Tech Tip Bulletin
031511

Premature Tie Rod End Failure

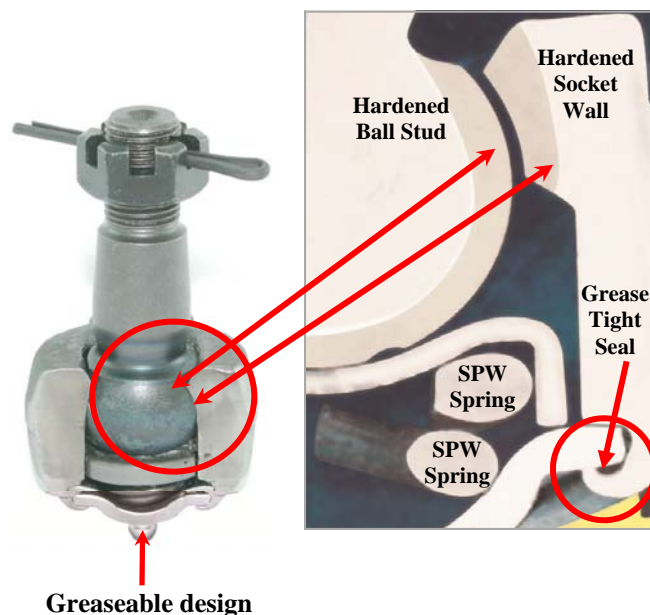
Premature tie rod end failure is commonly caused by contaminants leaking past the OE boot retaining ring. The original design is non-serviceable and unable to flush out contaminants.

Water gets trapped in the lip of the dust boot and seeps past the retaining ring.

- Pronto® tie rod ends are made with high grade Molybdenum alloy steel ball studs running on a carbon steel socket wall.
- Socket walls are **forged vs. cast** to provide greater strength-to-weight ratio.
- “SPW” Spring design provides better energy absorption and ensures the ball socket remains correctly positioned in all driving conditions.
- “Grease Tight Seal” design is watertight and ensures lubrication stays in the assembly & won’t leak.
- Greaseable design allows fresh grease to displace any debris away from the assembly.
